UNITED STATES PATENT AND TRADEMARK OFFICE

APPLICATION NO.	FILING DATE	FIRST NAMED INVENTOR	ATTORNEY DOCKET NO.	CONFIRMATION NO.
10/671,629	09/29/2003	Kyoung Ho Kim	1594.1244	6232
21171	7590	09/13/2004	EXAMINER	
STAAS & HALSEY LLP			VAN, QUANG T	
SUITE 700			ART UNIT	
1201 NEW YORK AVENUE, N.W.			PAPER NUMBER	
WASHINGTON, DC 20005			3742

Office Action Summary

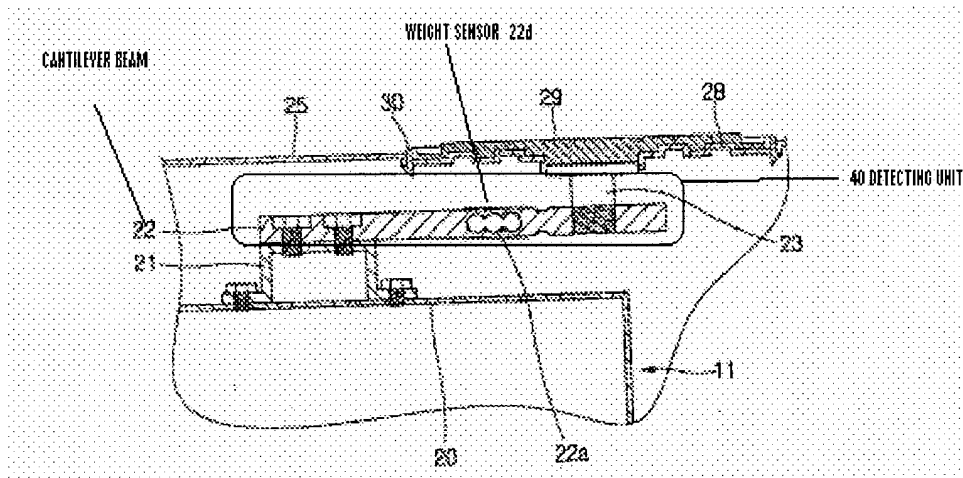
1. The drawings are objected to because "a weight detecting unit 40 and a support unit 41" recited in specification, page 4, par. 0020, line 3 is not shown in drawings. Corrected drawing sheets in compliance with 37 CFR 1.121(d) are required in reply to the Office action to avoid abandonment of the application. Any amended replacement drawing sheet should include all of the figures appearing on the immediate prior version of the sheet, even if only one figure is being amended. The figure or figure number of an amended drawing should not be labeled as "amended." If a drawing figure is to be canceled, the appropriate figure must be removed from the replacement sheet, and where necessary, the remaining figures must be renumbered and appropriate changes made to the brief description of the several views of the drawings for consistency. Additional replacement sheets may be necessary to show the renumbering of the remaining figures. The replacement sheet(s) should be labeled "Replacement Sheet" in the page header (as per 37 CFR 1.84(c)) so as not to obstruct any portion of the drawing figures. If the changes are not accepted by the examiner, the applicant will be notified and informed of any required corrective action in the next Office action. The objection to the drawings will not be held in abeyance.

The examiner realizes that Applicant may be his or her own lexicographer as long as the meaning assigned to the term is not repugnant to the term's well known usage. In re Hill, 161 F.2d 367, 73 USPQ 482 (CCPA 1947). However, in this case, Applicant use of the term "sensor" in the claims is repugnant to the standard use of the term in the art. Applicant's weight sensor, in the specification and in Figure 3, is actually a cantilever beam (22). But, the sensing element (22d) is actually the "sensor" because it senses and detects a weight according to a force applied to a free end of the cantilever beam. A "sensor" is used in the art is an electronic component that detects weight. Thus, a "sensor" is not a cantilever beam or plate such as beam 22 in the specification.

Therefore, the Applicant must change in the specification and in the claims the term "weight sensor 22" to "a cantilever beam 22". Further, for clarification, the Examiner has reproduced figure 3 of the application to clarify the examiner's interpretation of the "detecting unit 40", the cantilever beam 22" and "the weight sensor 22d".

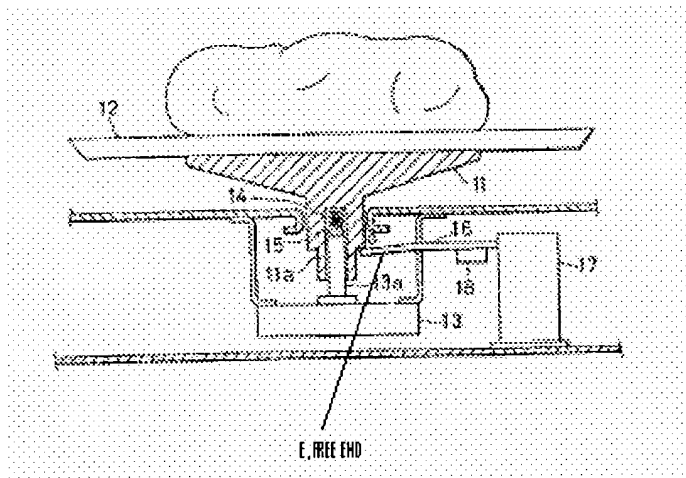
6. Claims 1-2, 6, 8-13, 17-18, 20 and 40 are rejected under 35 U.S.C. 102(b) as being anticipated by Hisaya (JP59215519A). Hisaya discloses cooking utensil comprising a weight detecting unit (16+18) comprising a weight sensor (18), said weight detecting unit supported at an end thereof, and detecting a weight according to a force applied to a free end (E, figure below) thereof; and a support unit (17) to support the weight detecting unit (16+18).

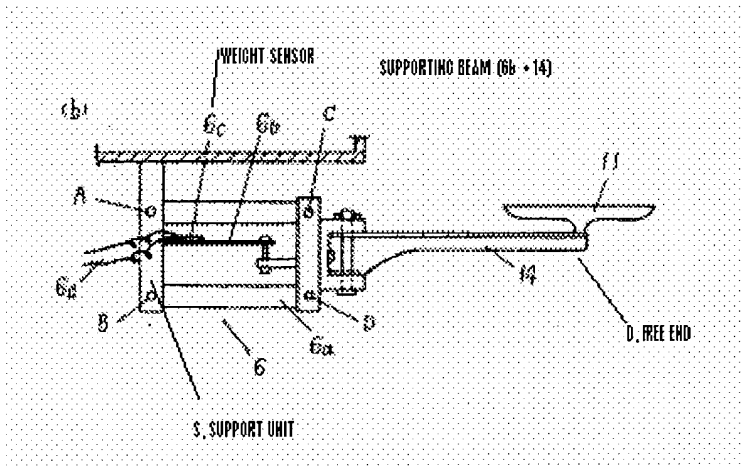
7. Claims 1-2, 9-13 and 20 are rejected under 35 U.S.C. 102(b) as being anticipated by Masaaki (JP57155035A). Masaaki discloses a microwave heater comprising a weight detecting unit (6) comprising a weight sensor (6C), said weight detecting unit (6) supported at an end thereof, and detecting a weight according to a force applied to a free end (D, figure below) thereof; and a support unit (S) to support the weight detecting unit.
